Final Main Installation Focused Feasibility Study Report

Defense Depot Memphis, Tennessee U.S. EPA I.D. Number TN4210020570

July 2024

U.S. Army Corps of Engineers, Mobile District Contract No. W91278-16-D-0061 Task Order No. W9127819F0535

ment Path: W:/Feasibiltiy Study/FFS/13_TCE_FAQ_Apr202

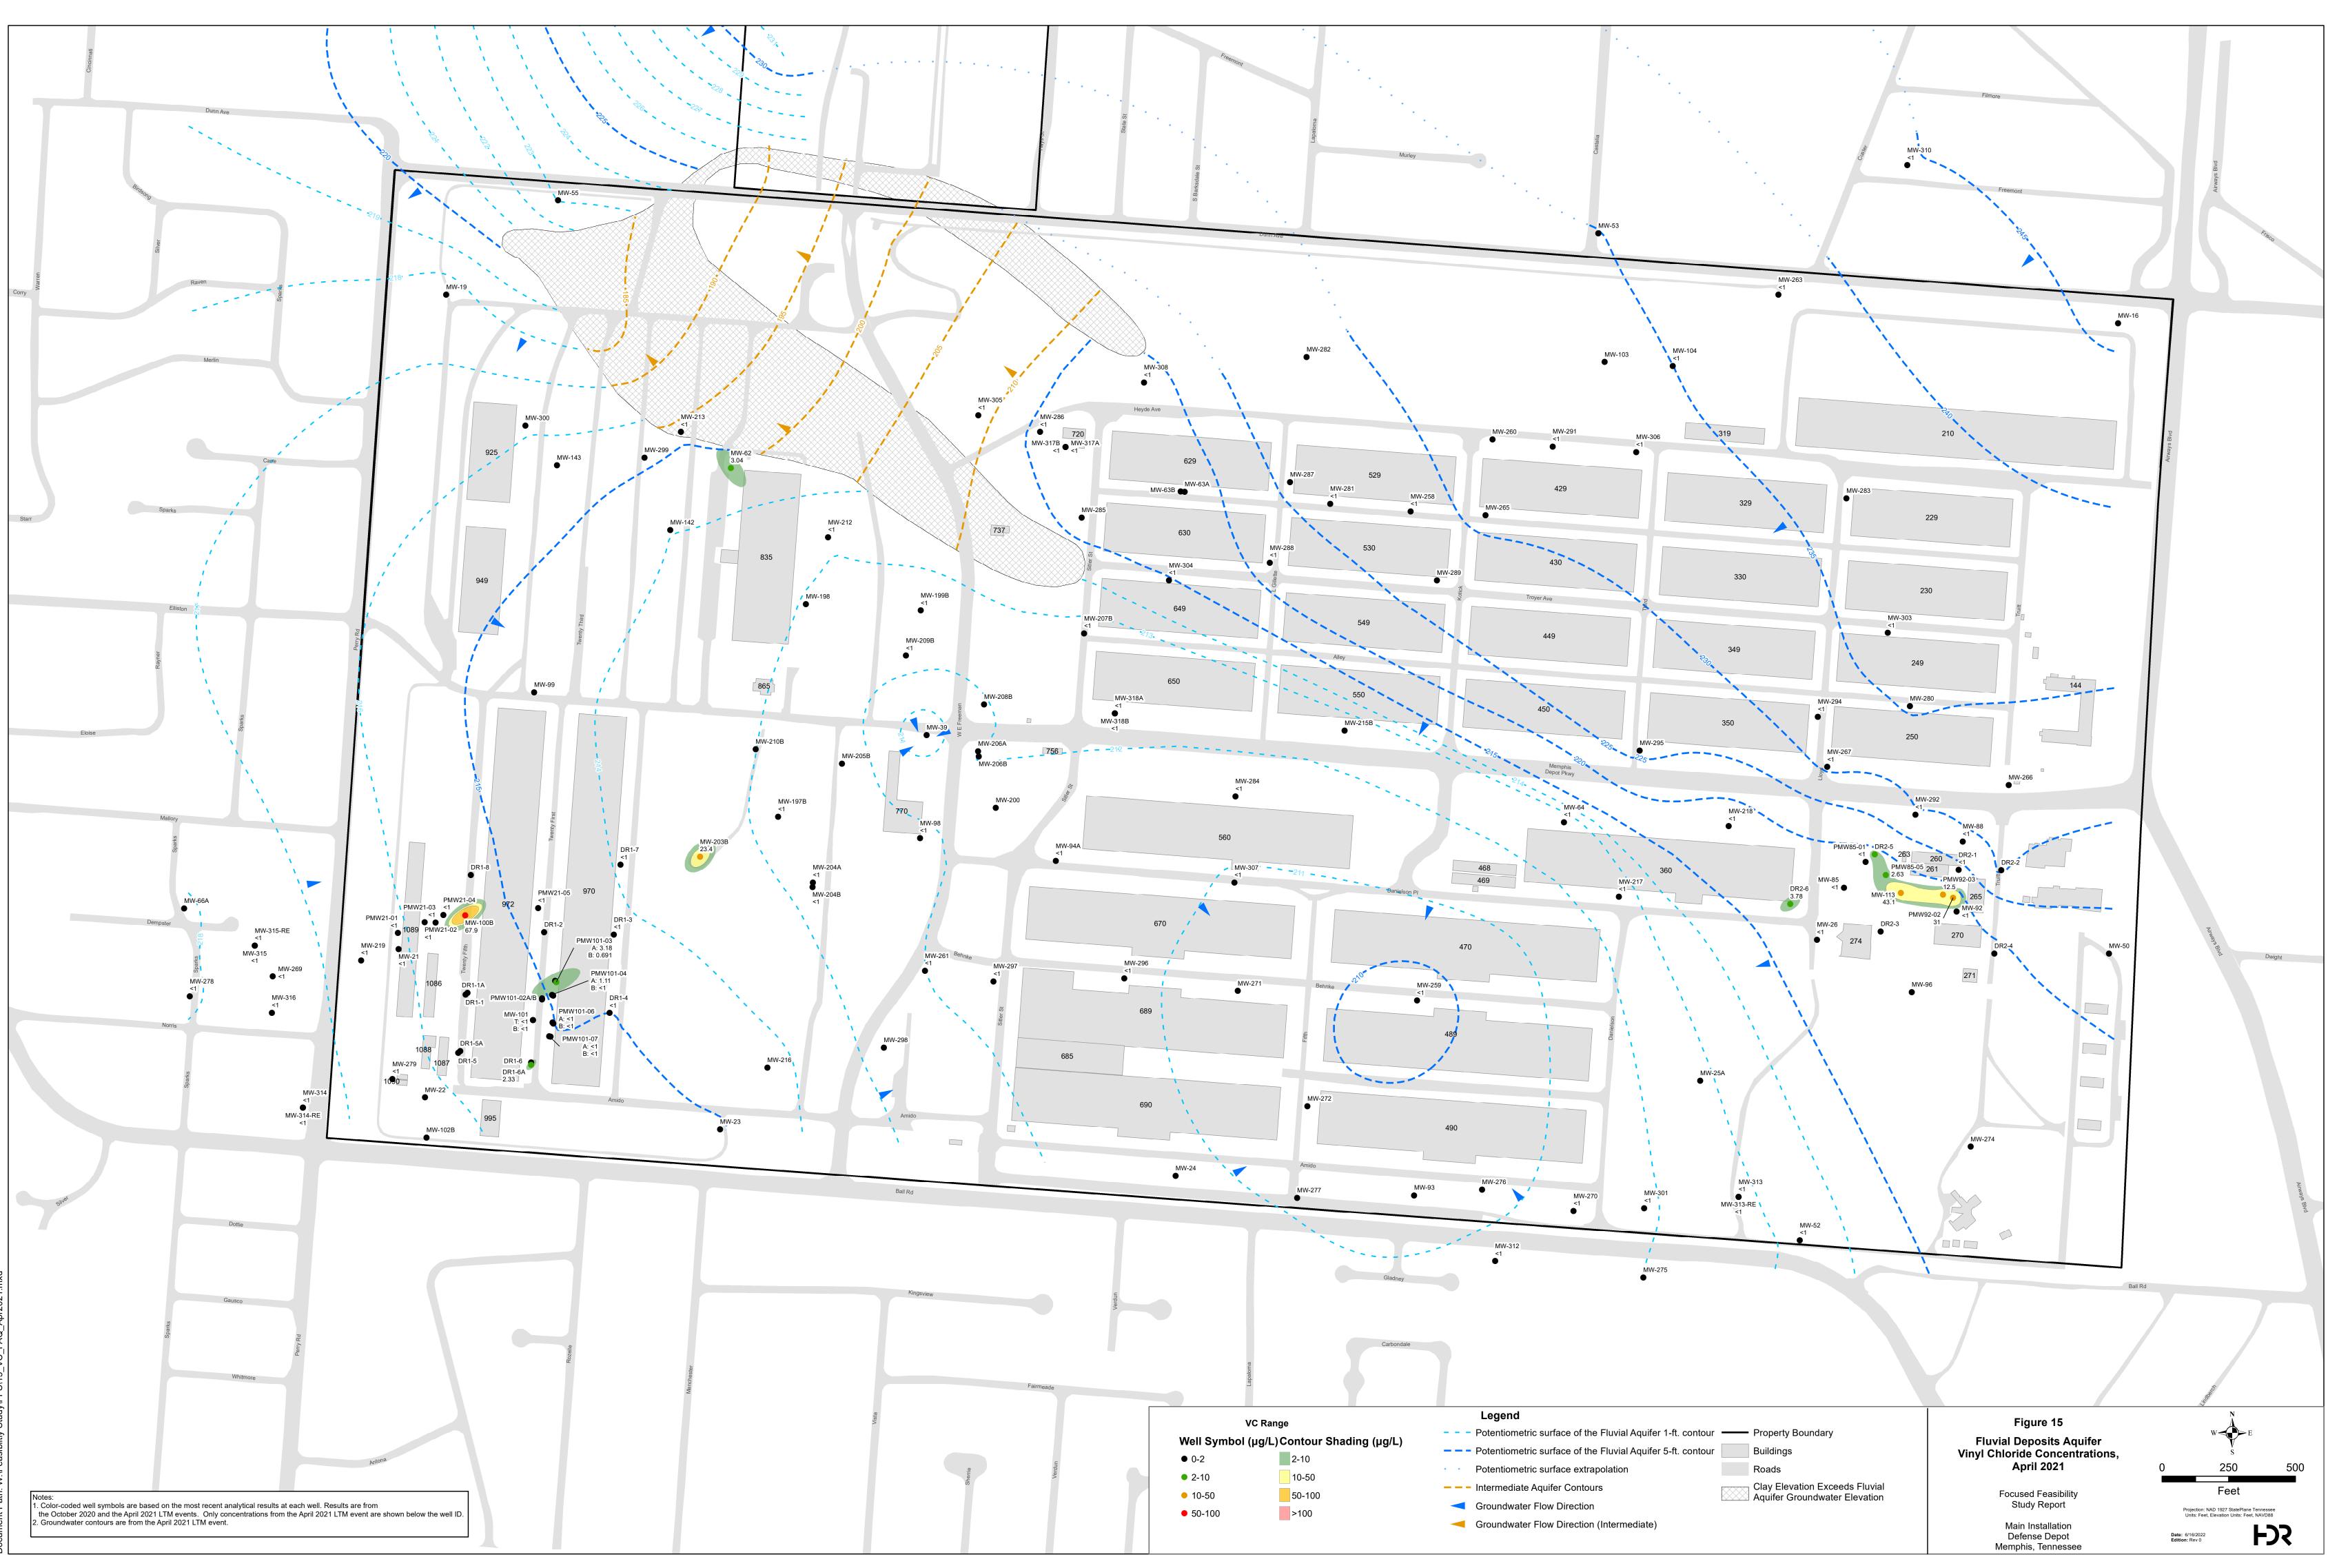
Moreover, Figure 18 shows chlorinated VOC detections in the Memphis Sand Aquifer. As part of the monitoring plan, downgradient monitoring locations will need to be installed.

- 12. Section 1.2.6.2.8, Hydraulic Connections IAQ and MAQ, Page 1-15: The final sentence of this section states that there is no plume in the MAQ; however, according to Figure 18 (Memphis Aquifer CVOC Concentrations, April 2021) tetrachloroethylene (PCE) was detected above the USEPA Maximum Contaminant Level (MCL) of 5 μg/L in monitoring wells MW-254 and MW-140, which are in the northeast portion of the MI. It should be noted there is no MAQ well to the southwest to bound these PCE exceedances. Based on the proximity of MW-254 and MW-140, a potential undefined PCE plume appears to be present in the MAQ in the northwest portion of the MI. Please revise the text to discuss this potential PCE plume in the MAQ.

12. Section 1.2.6.2.8, Hydraulic Connections – IAQ and MAQ, Page 1-15: The final sentence of this section states that there is no plume in the MAQ; however, according to Figure 18 (Memphis Aquifer CVOC Concentrations, April 2021) tetrachloroethylene (PCE) was detected above the USEPA Maximum Contaminant Level (MCL) of 5 μg/L in monitoring wells MW-254 and MW-140, which are in the northeast portion of the MI. It should be noted there is no MAQ well to the southwest to bound these PCE exceedances. Based on the proximity of MW-254 and MW-140, a potential undefined PCE plume appears to be present in the MAQ in the northwest portion of the MI. Please revise the text to discuss this potential PCE plume in the MAQ

As stated in Response SC5, contaminant concentrations in the MAQ in the downgradient area of the plume, within the erosional window, are only slightly above the MCL. Concentrations in upgradient wells in the MAQ and lower IAQ are not significantly higher (see Figure 10 of the FFS). Groundwater modeling estimated concentrations would decrease below 1 μ g/L within approximately 2,000 ft from the MI. Response SC5 states that active remediation at Building 720, within the window, will "reduce concentrations in downgradient wells including MAQ wells ...".
